**Re: Starbuck's
700 Juan Tabo NE
Request Temporary C.O. - Accepted
Engineer's Stamp dated: 3-12-15 (K22D006B)
Certification dated: 8-23-15**

GRADING & DRAINAGE PLAN

C301

**RE: Starbucks Coffee Company
700 Juan Tabo NE, Albuquerque, NM
Drainage Conformance Letter**

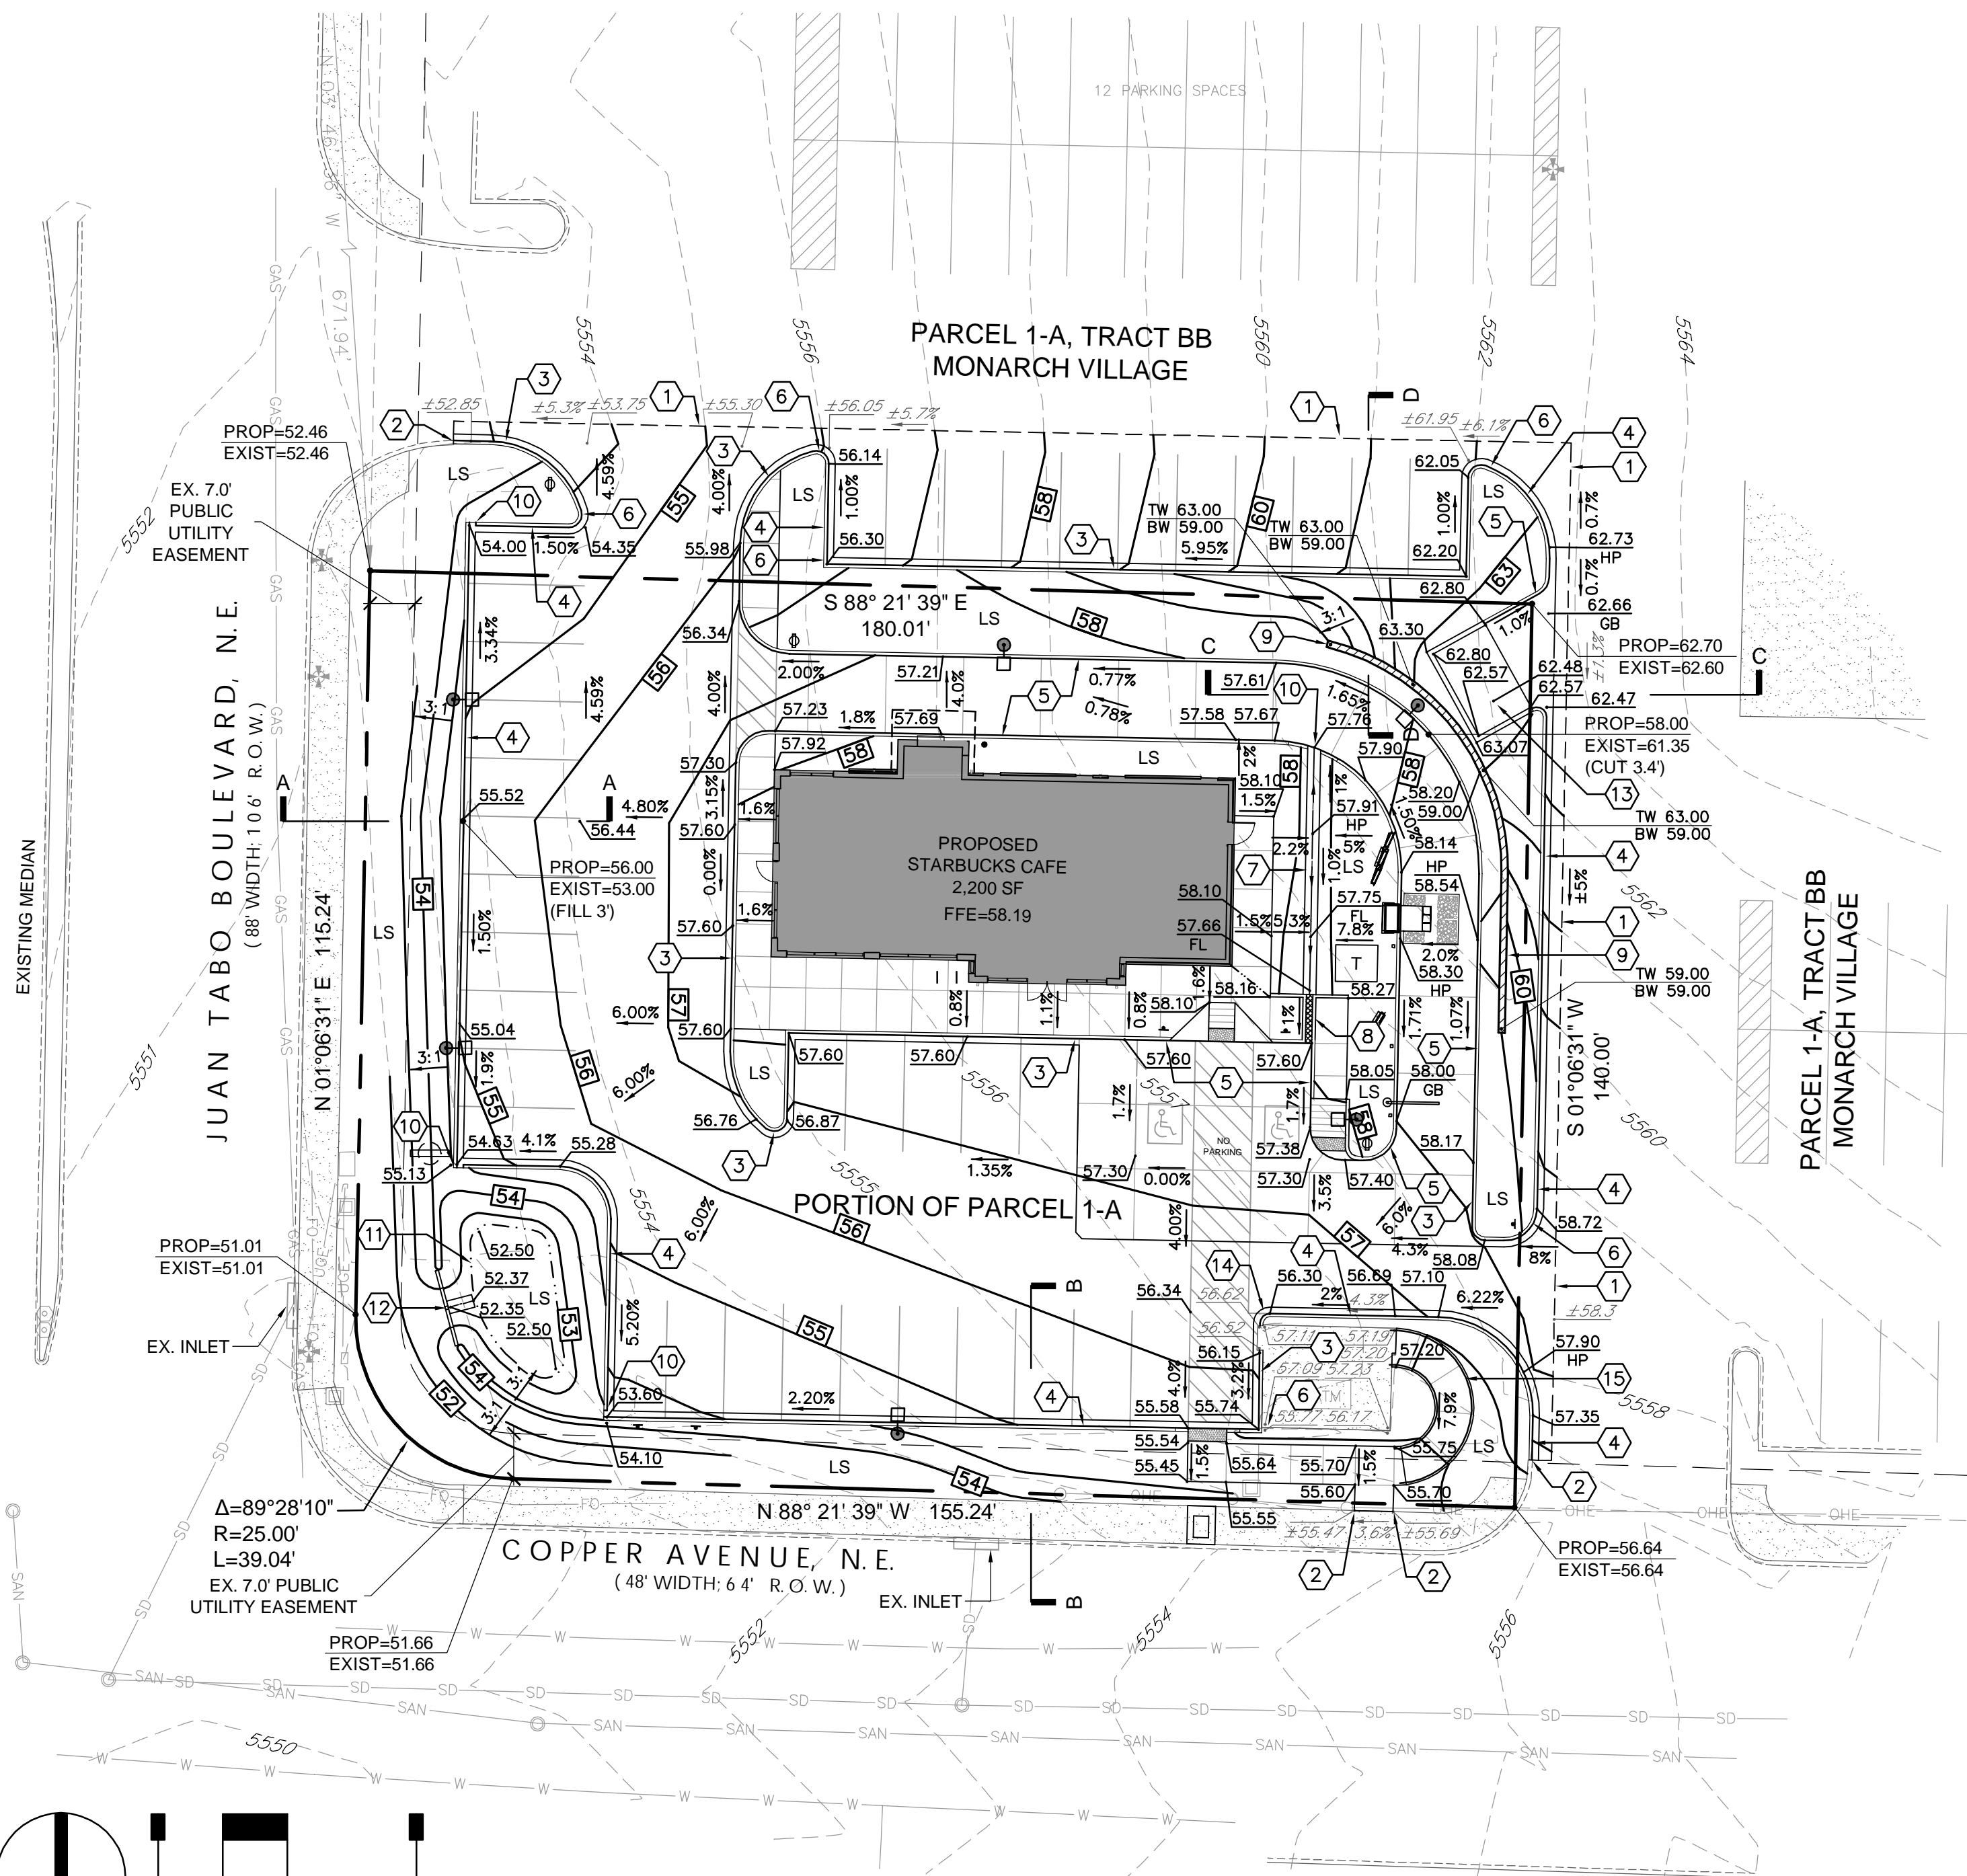
From my review of the photos, it appears the 2-foot wide concrete valley pan to be located between the proposed building and drive-through lane entry has been constructed. The photos also indicate construction of the sidewalk culvert associated with this pan. In addition, the photos indicate one of the four curb openings (at the far southwest corner of the site) to have been constructed.

Based on this review of the photographs provided, and of this information only; it appears the improvements listed herein have been located in general conformance with the approved plan(s).
